CREM ONE – SOFTWARE UPDATES

Rev: 07 (28 Nov 2022)

ONE 2 Boilers (8092/8093/9084)

Update version: Full 1.16

10) Flowmeter model selection.

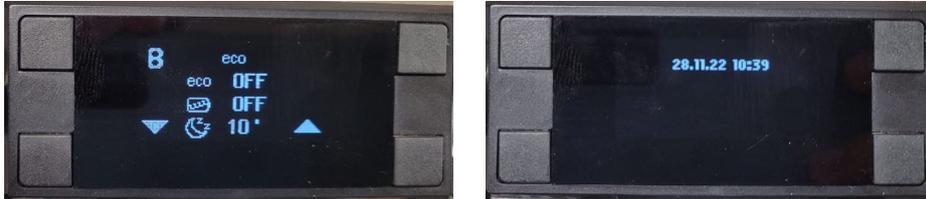
Selection of the flowmeter model, due to the implementation of the brass flowmeter replacing the plastic version, but to keep compatibility with machines in field.

A: Plastic

B: Brass (New default)
